Phase IV PRIVATE SANITARY SEWER IMPROVEMENTS

Willowood Estates CITY OF WICHITA, KANSAS

906 PPS (607861)

PRIVATE SANITARY SEWER IMPROVEMENTS
LINE 1
WILLOWOOD ESTATES - PHASE 4

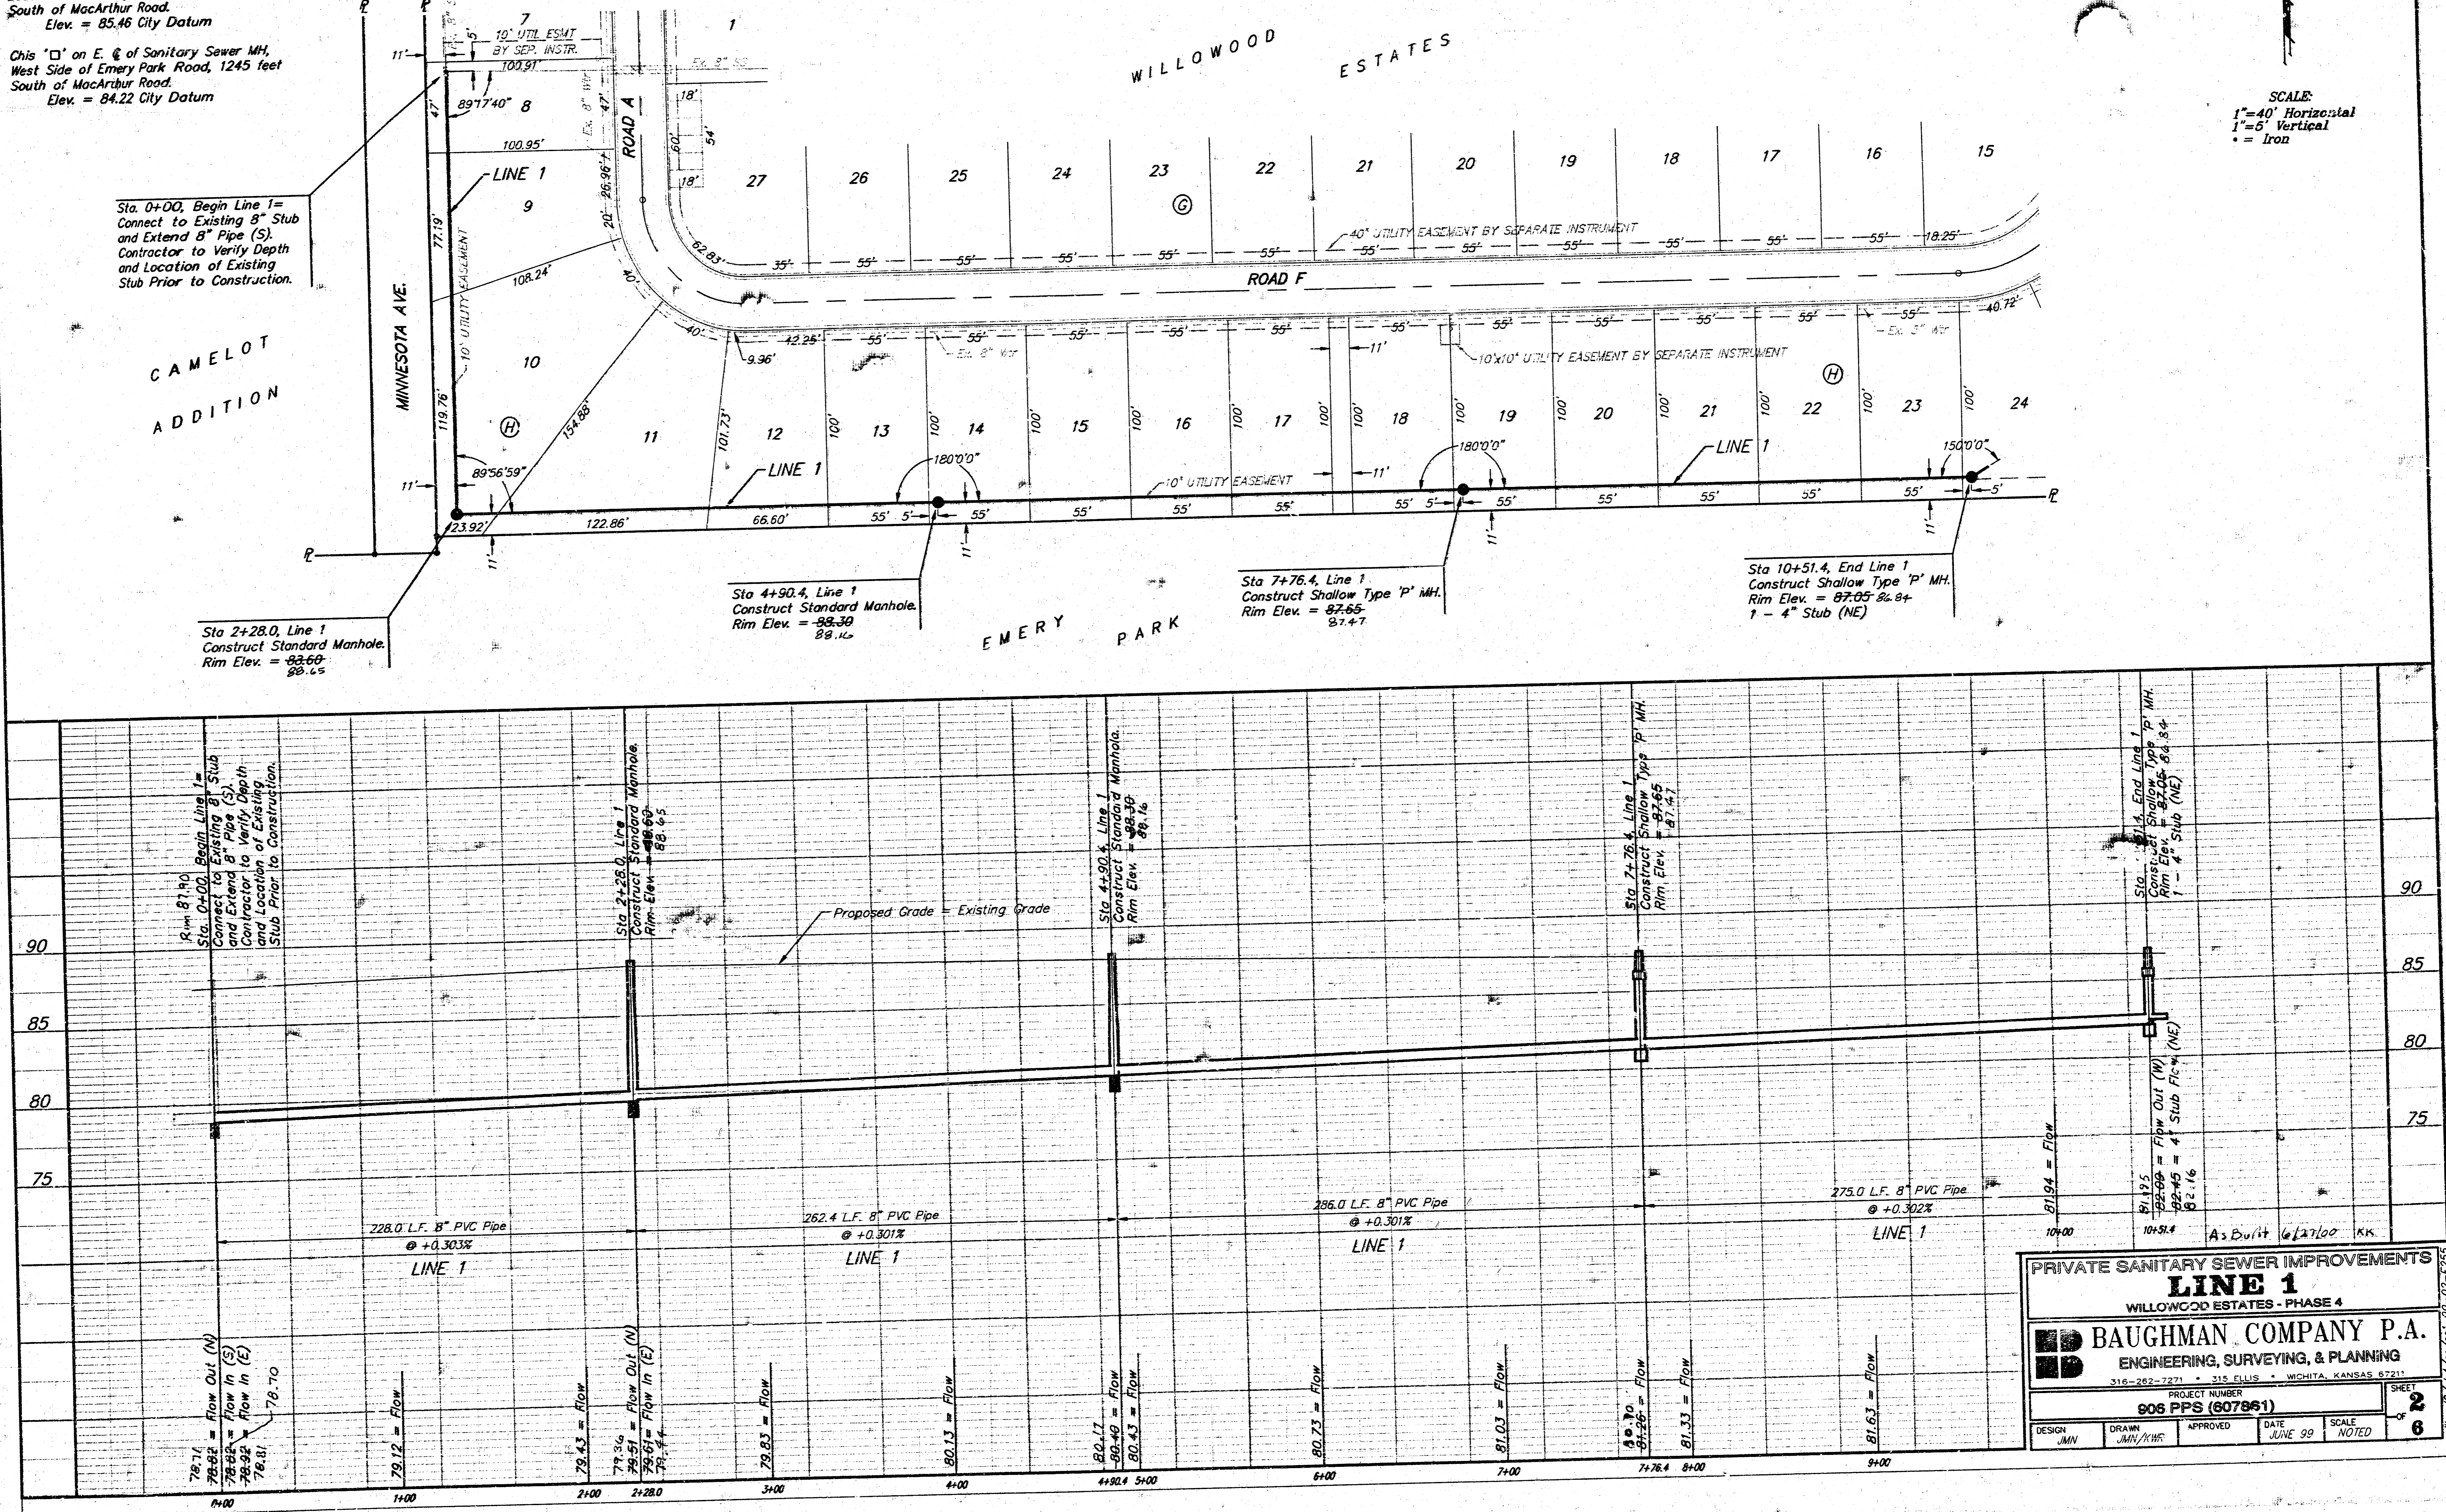
Sta 2+28.0, Line 1 Construct Standard Manhole. Rim Elev. = 83.60
83.65

Sta 4+90.4, Line 1 Construct Standard Manhole. Rim Elev. = 83.30
83.16

Sta 7+76.4, Line 1 Construct Shallow Type 'P' MH. Rim Elev. = 87.85
87.47

Sta 10+51.4, End Line 1 Construct Shallow Type 'P' MH. Rim Elev. = 87.85
82.84
1 - 4" Stub (NE)
